RE: Application for Sign Permit
1101 W. University Dr. Rochester Hills, MI
HENRY FORD HEALTH

We are in receipt of your applications for multiple sign permits for the above-referenced location. However, some of your applications do not meet the requirements as set forth in our Ordinance for the following reason(s):

**HENRY
FORD
HEALTH**

E28 SITE PLAN & SETBACKS

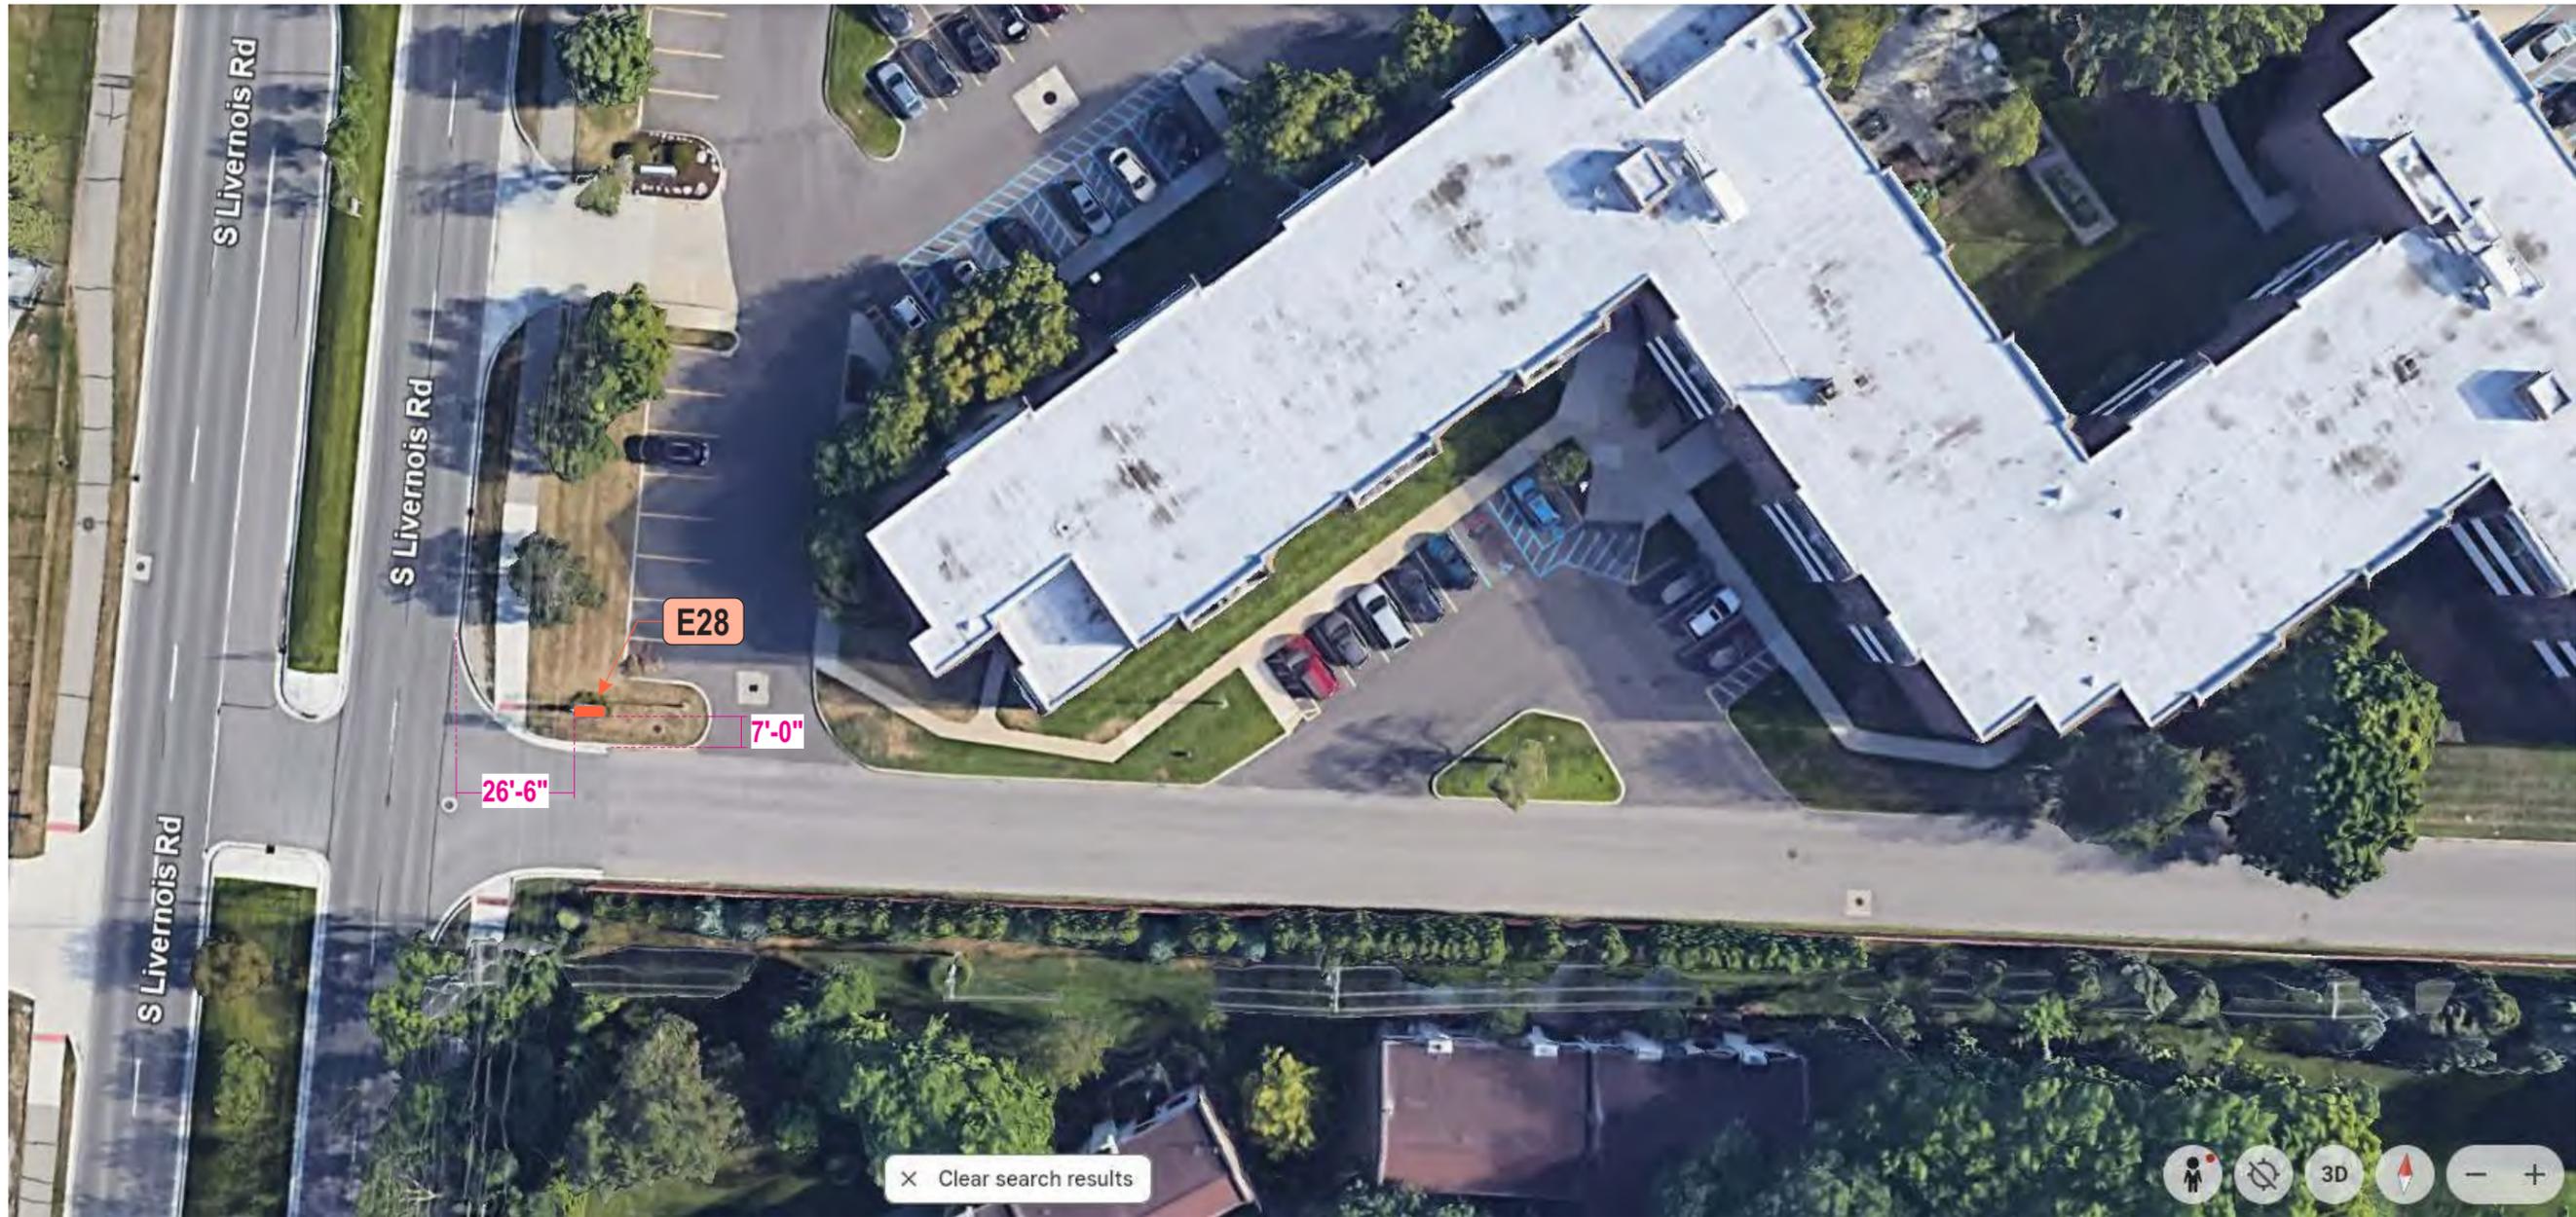
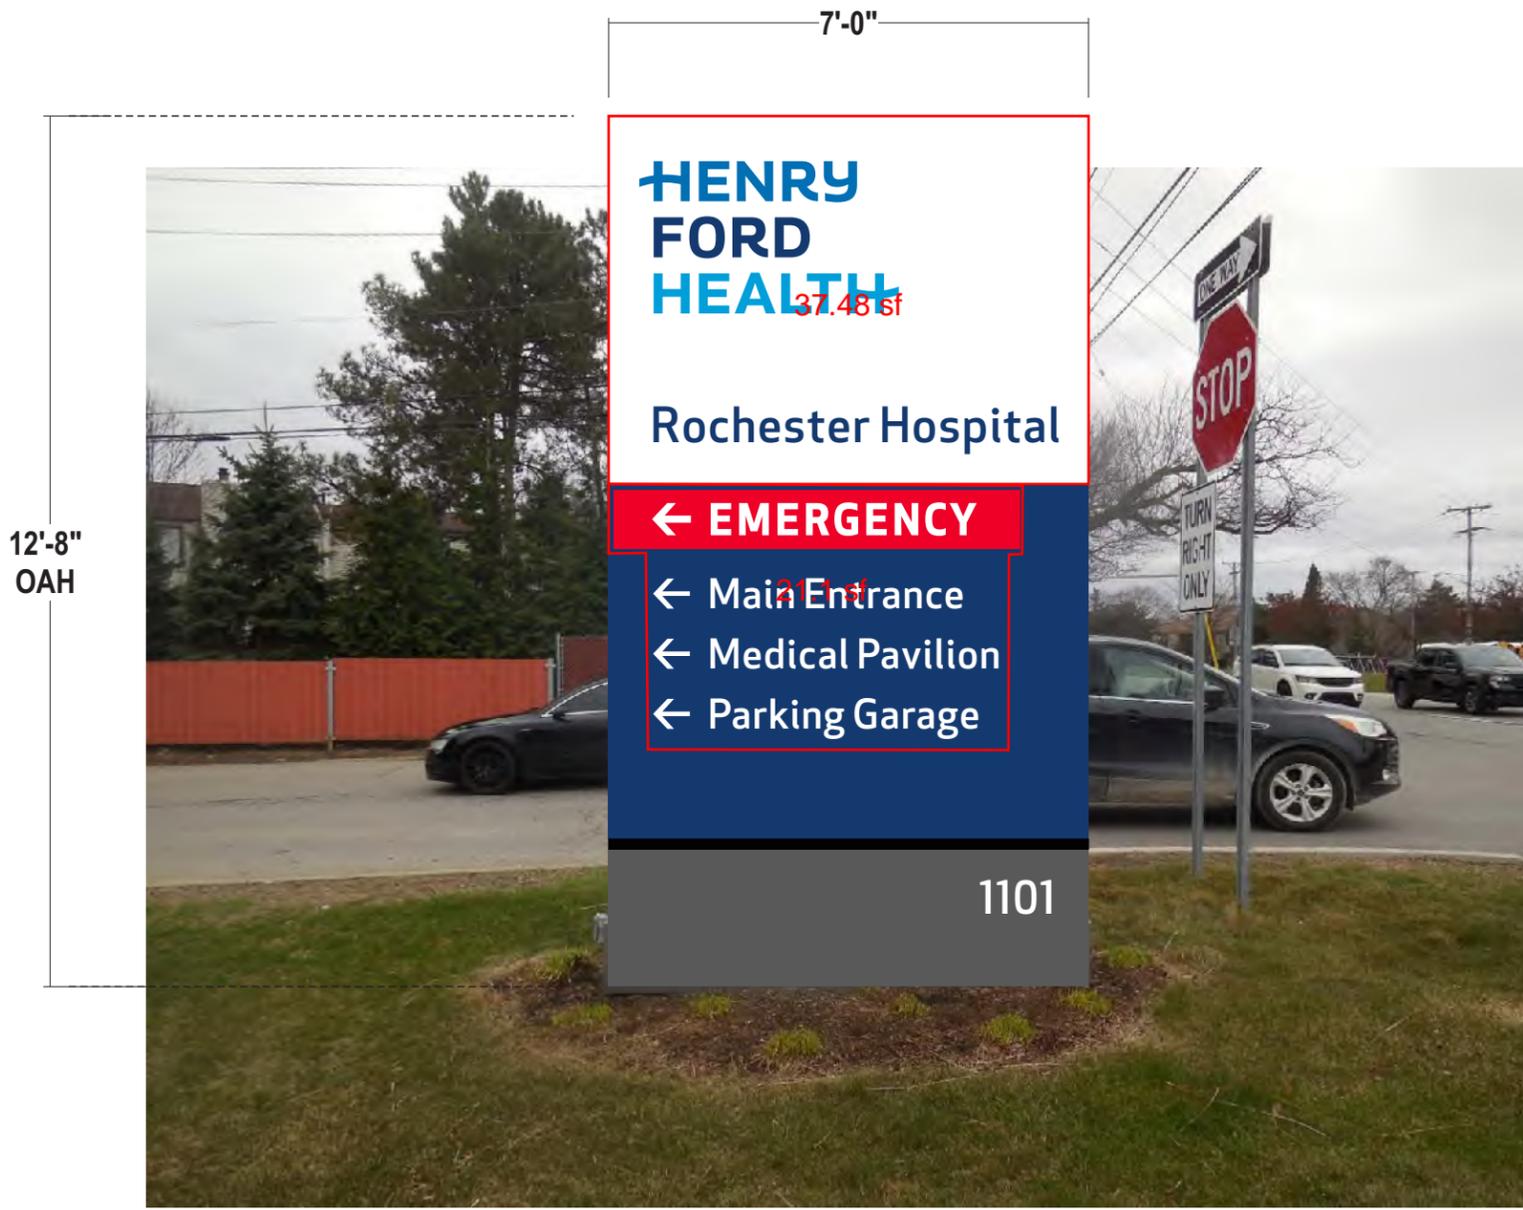
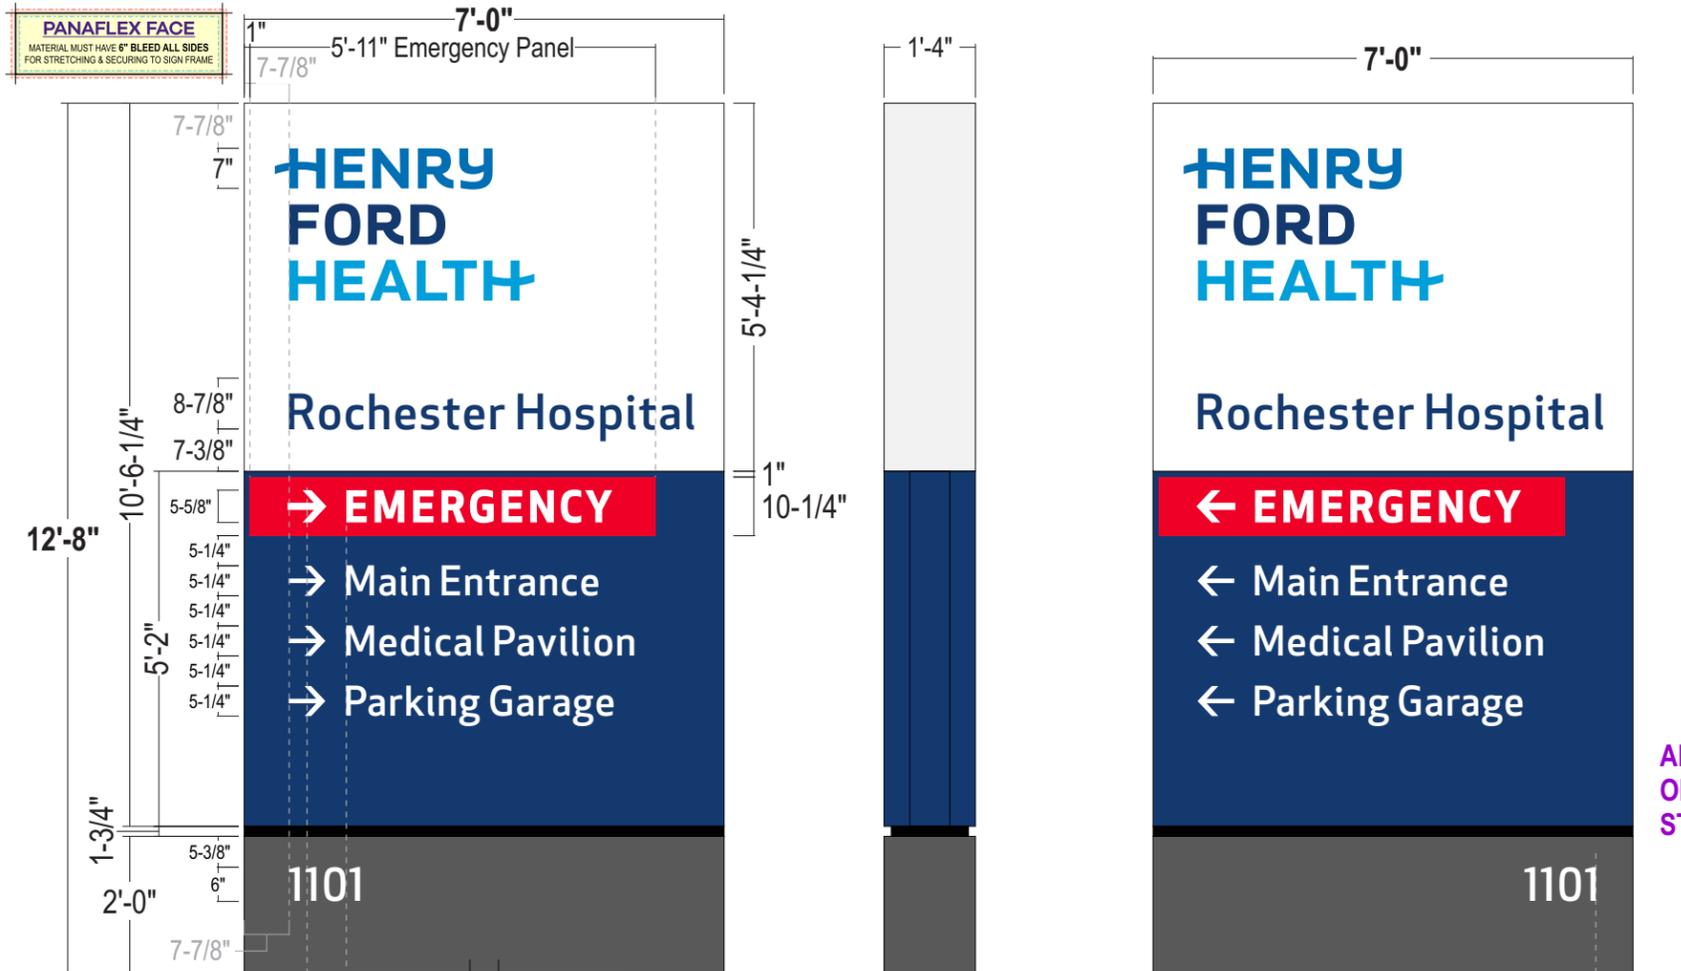
Sign E28 – Monument sign replacement with new footing. The proposed sign is 58.58 square feet (measured around the top illuminated panel and illuminated copy on bottom panel; address is not included), and a proposed height of 12.67 feet.

The proposed total sign area of 58.58 square feet is in violation of the maximum area by 38.58 square feet.

The proposed monument sign height of 12.67 feet is in violation of the maximum height by 5.67 feet.
